RE: JMC Project 20101
Summit Club Residential
Bedford Road (Route 22)
Town of North Castle, NY

Response to Town Comments Resubmission

Town of North Castle Planning Department, dated March 17, 2021

DRAWING NO.
LS100

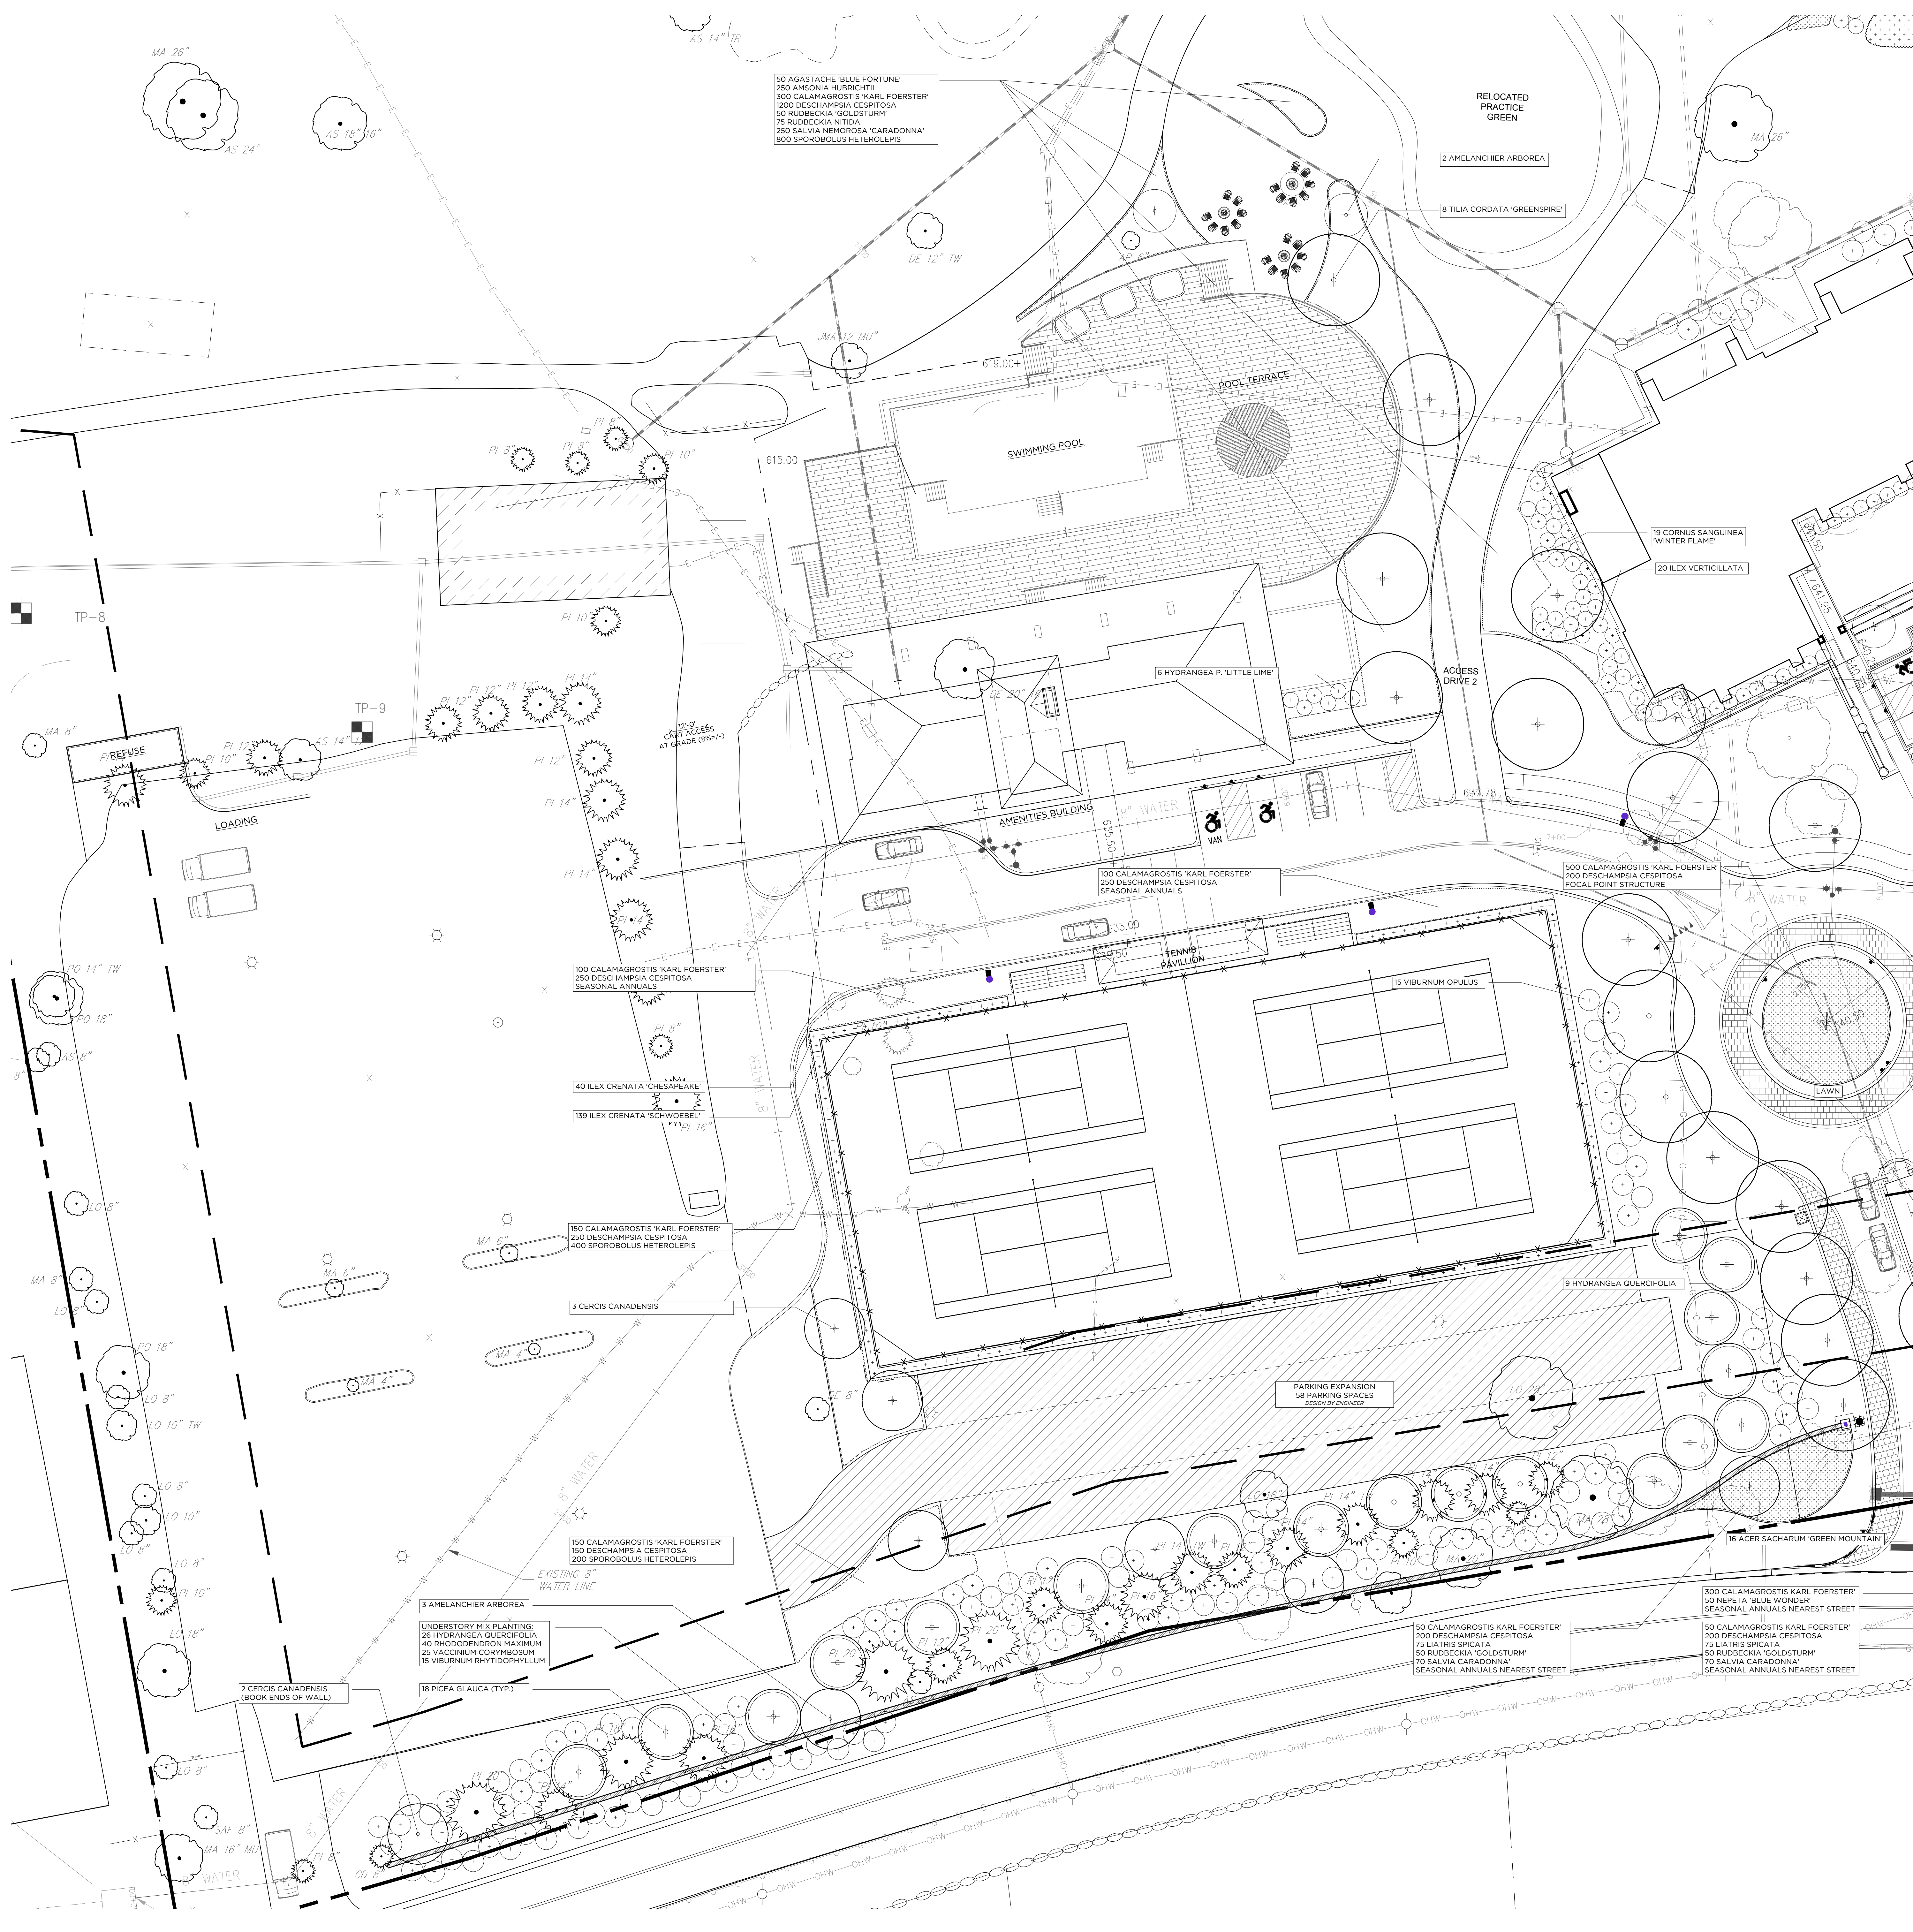
The site plan depicts new tennis courts (structures) in the “front yard” of the property. While the tennis courts have been removed from the buffer, it is recommended that the site plan be revised to eliminate the tennis courts from the front yard since this area serves as the gateway to the project. This area should be incorporated into a formal landscaping/screening plan.

The tennis courts are convenient to the Amenities Pavilion and are an important component of the club’s athletic facilities. Substantial understory screening proposed along Rt 22, will serve to screen the courts from the road. Once bramble is removed to provide space for screening planting, a large number of existing trees are to be maintained, as shown on LS100. Please refer to plans and renderings prepared by Granoff Architects.

PROJECT TITLE: SUMMIT CLUB
 DRAWING TITLE: EXTERIOR LIGHTING PHOTOMETRIC CALCULATION
 SCALE: 1"=40'-0"
 DATE: 6/11/21
 DRAWN BY: LED
 SHEET: SL-1A
 FILE NAME: SL-1A SUMMIT CLUB 06-11-2021 LED.dwg

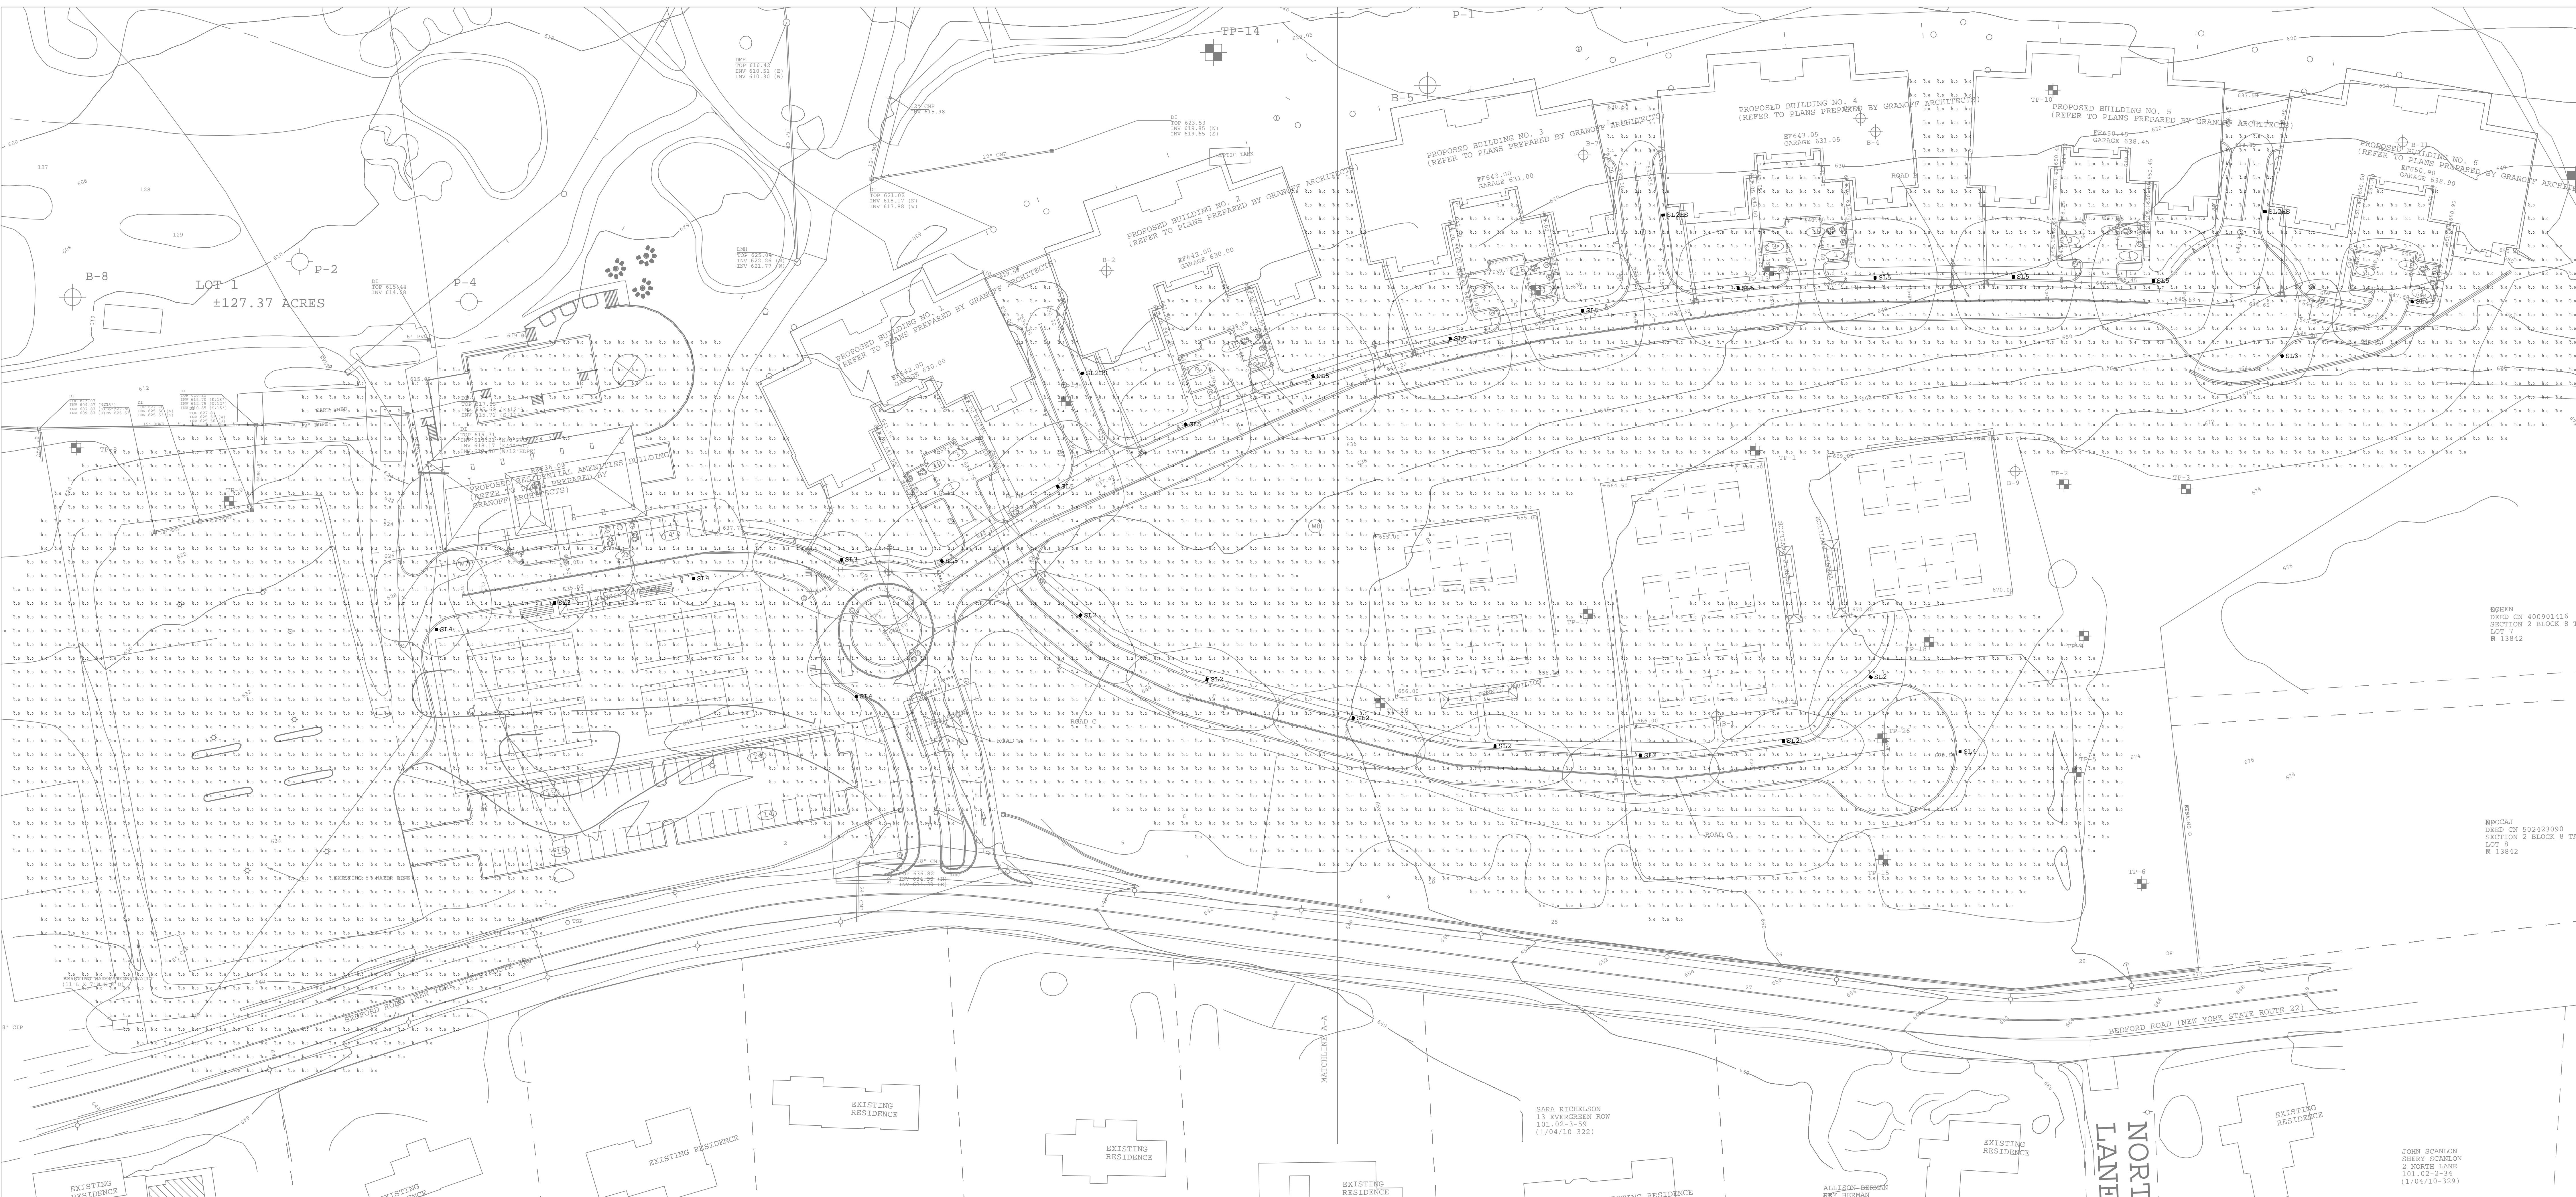
The site plan shall be revised to depict a lighting plan that conforms to the minimum requirements of Section 355-45.M of the Town Code. The Applicant should indicate whether the tennis courts are proposed to be lit.

A lighting plan conforming to the minimum requirements of Section 355-45.M of the Town code has been prepared and included in this submission. Please refer to plans prepared by Apex Lighting Solutions.
